May 10, 1976
Fort St. Vrain
Unit No. 1
P-76104

Subject: Attachment A & B to Replace P-76034 Transmittal

Information on Cable Non-Conformance

Figure 1

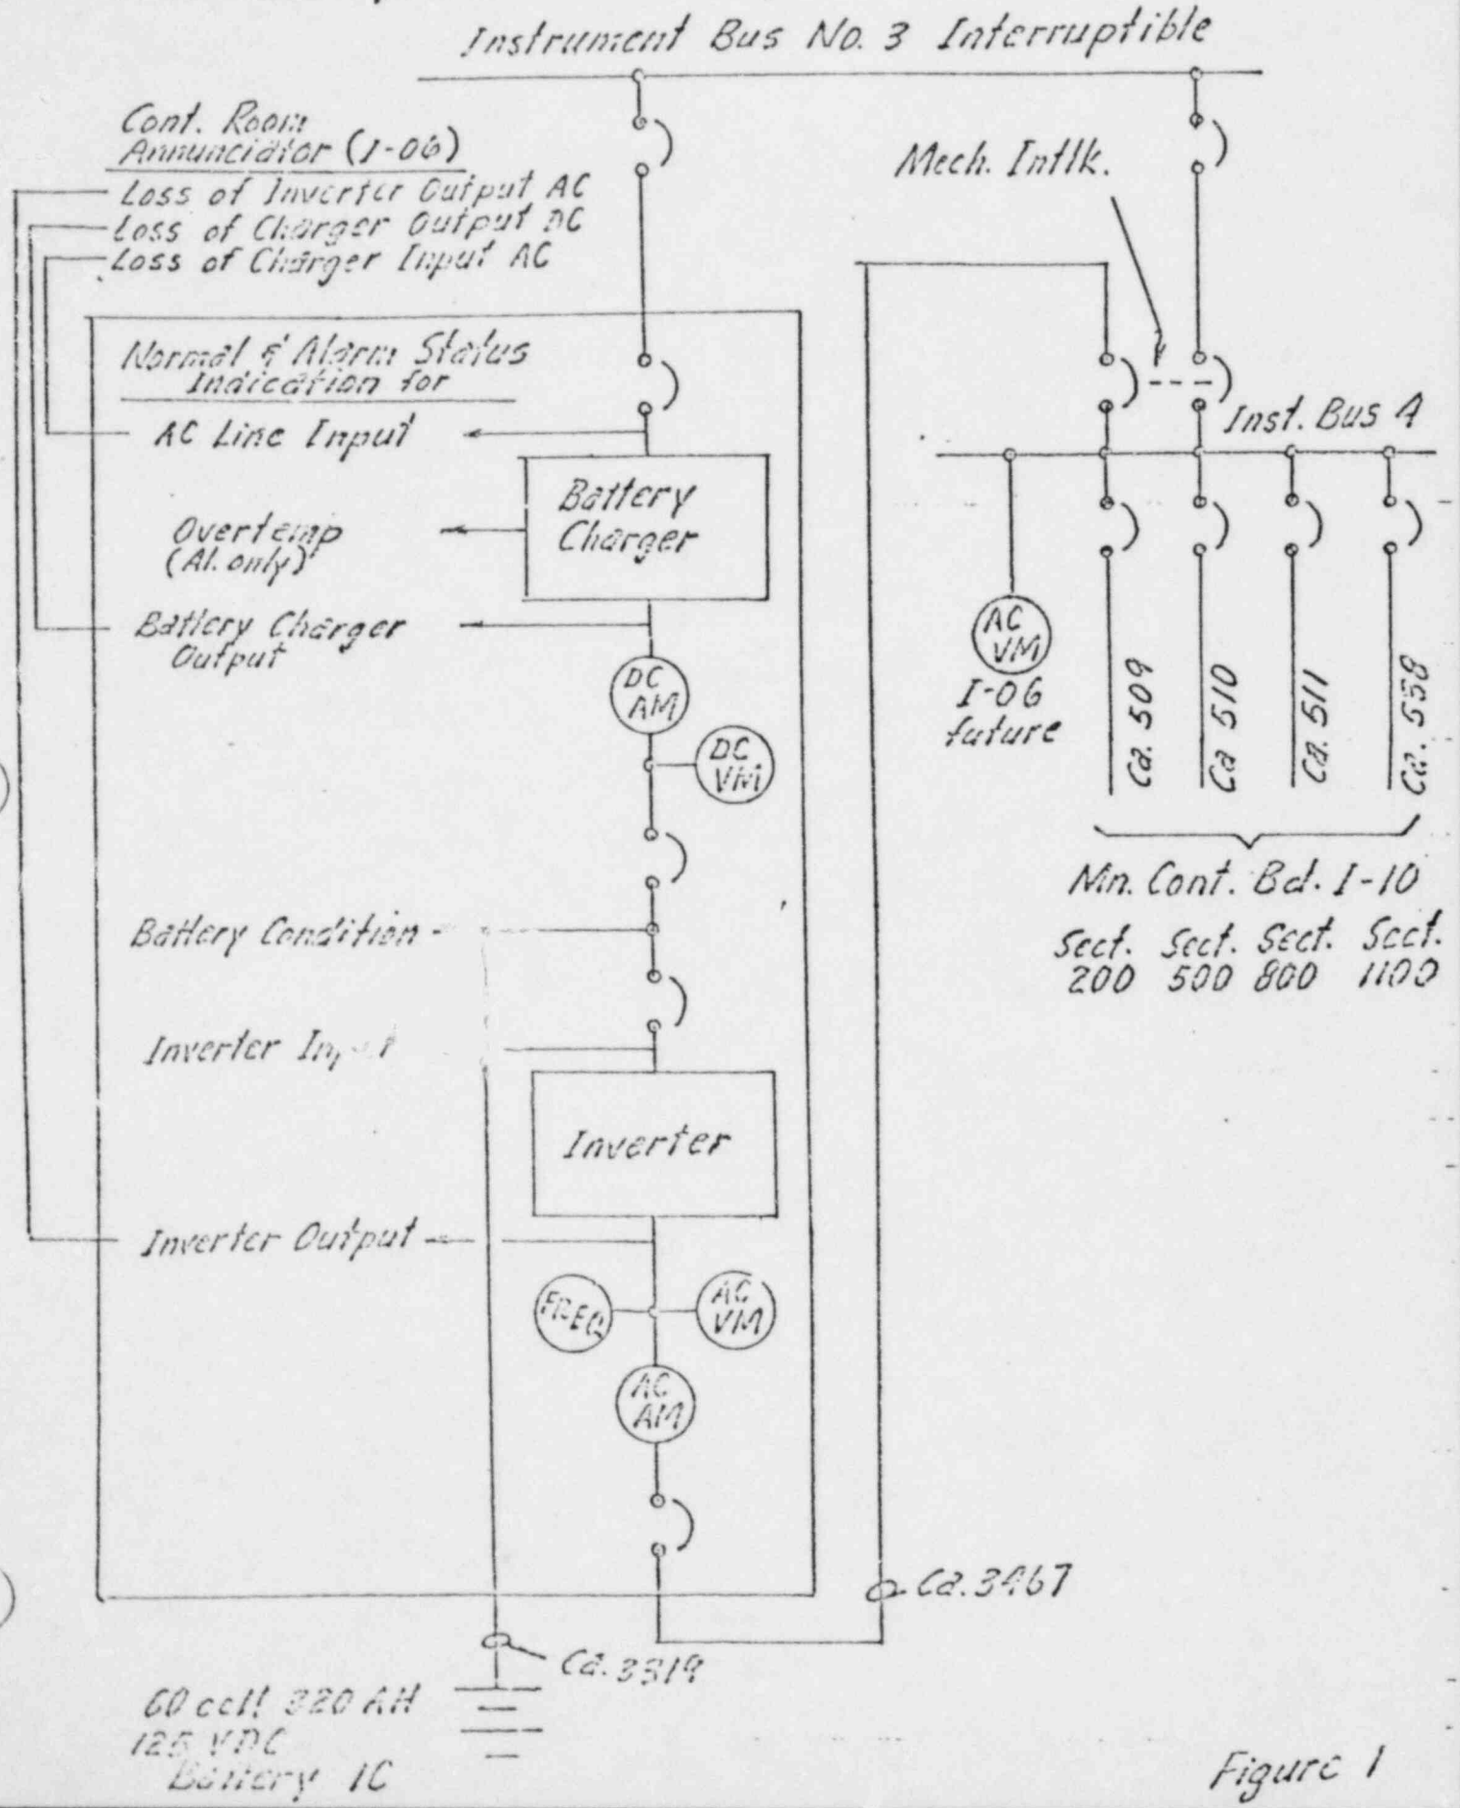
1. Paragraph 3, Discussion, Page 12 - Replace existing Discussion paragraph with the following:

A Class 1E battery charger, Class 1E inverter, and Class 1E battery have been installed which will provide a separate Class 1E power source for the plant protective system equipment presently being supplied by interruptible 120V AC, Bus 3. A separate seismic Class I Battery Room has been provided to house the new Class 1E battery.

The new non-interruptible 120V AC bus has been designated:

Cables 509, 510, 511 and 538 associated with the PPS are being reconnected from 120V Instrument Bus 3 to 120V Instrument Bus 4.

Figure 1, attached, indicates the electrical configuration of this new equipment.

Figure 5

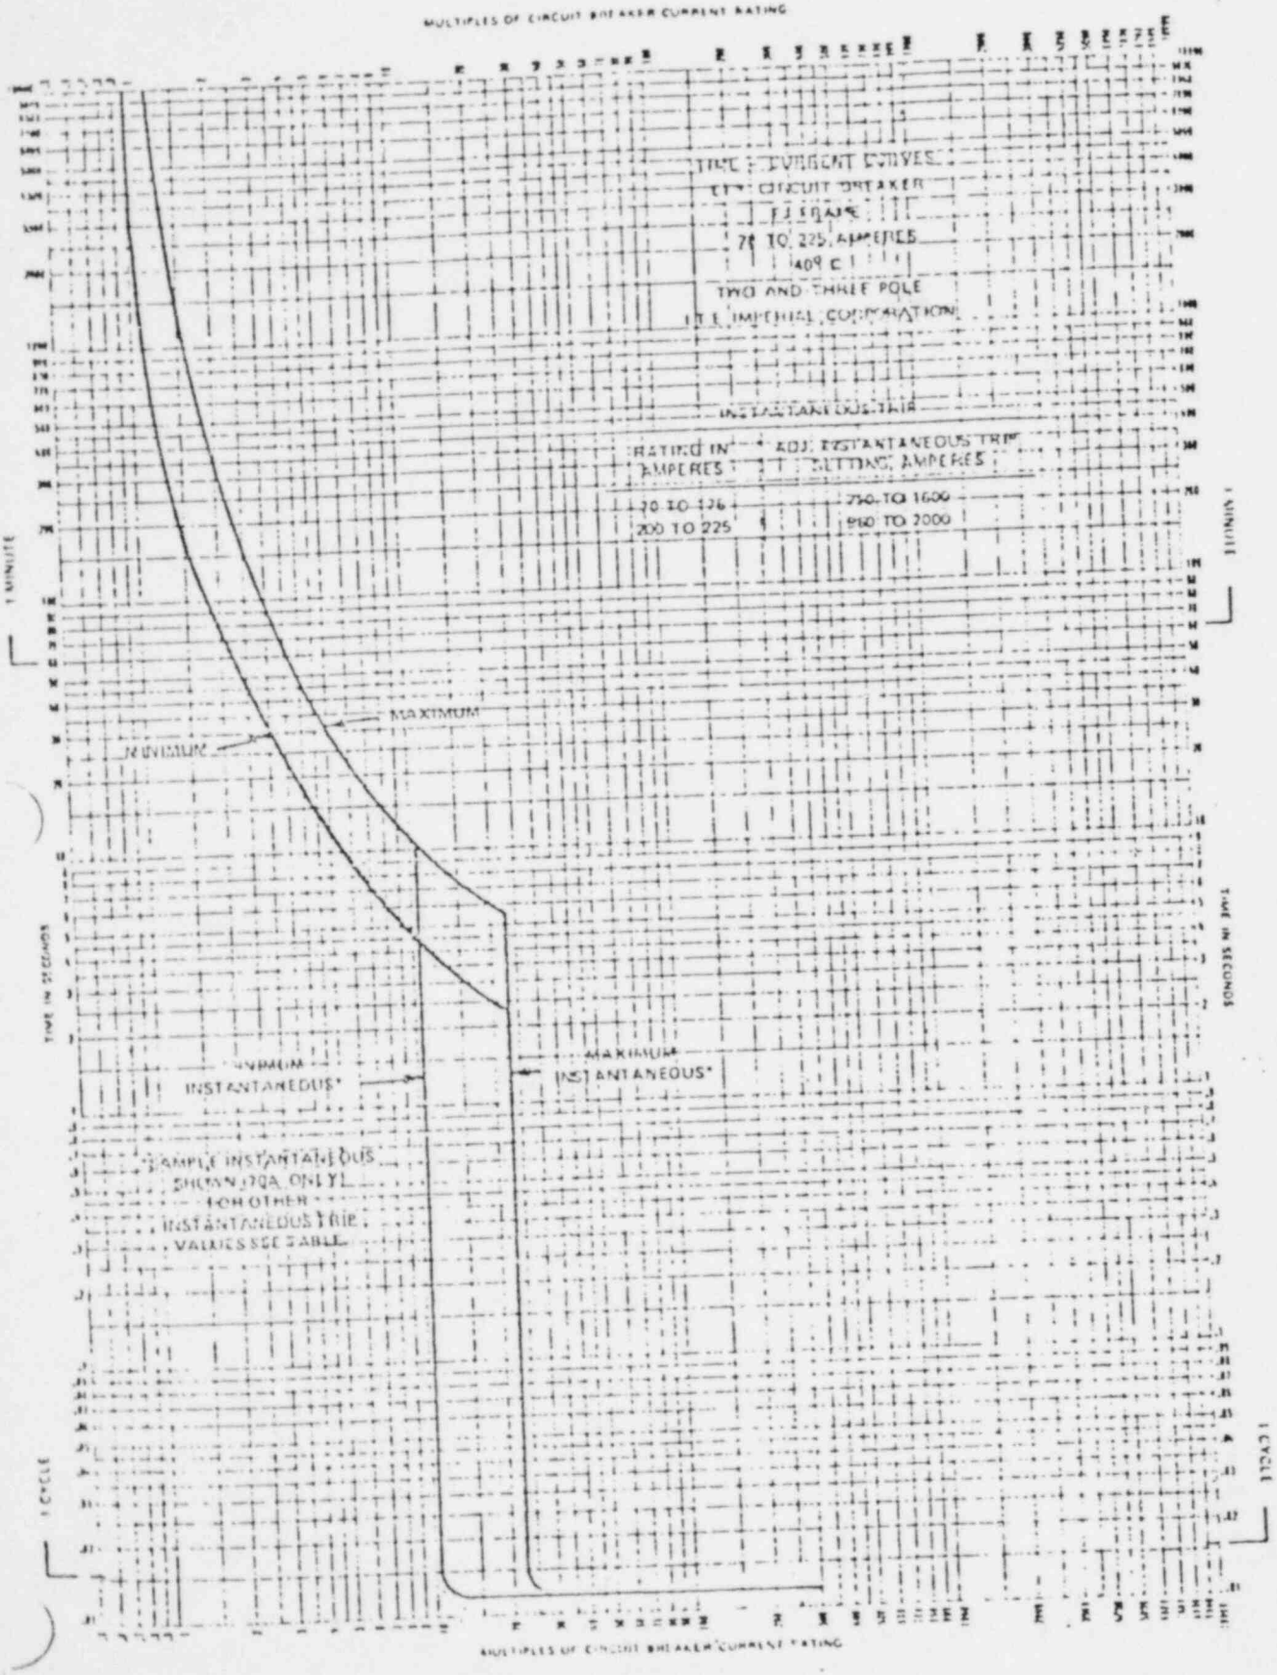
c) The third paragraph on page 4 references figures 2, 3, and 4. Additional curves are attached to this letter and the reference should now read figures 2, 3, 4, 5, 6, 7, and 8.
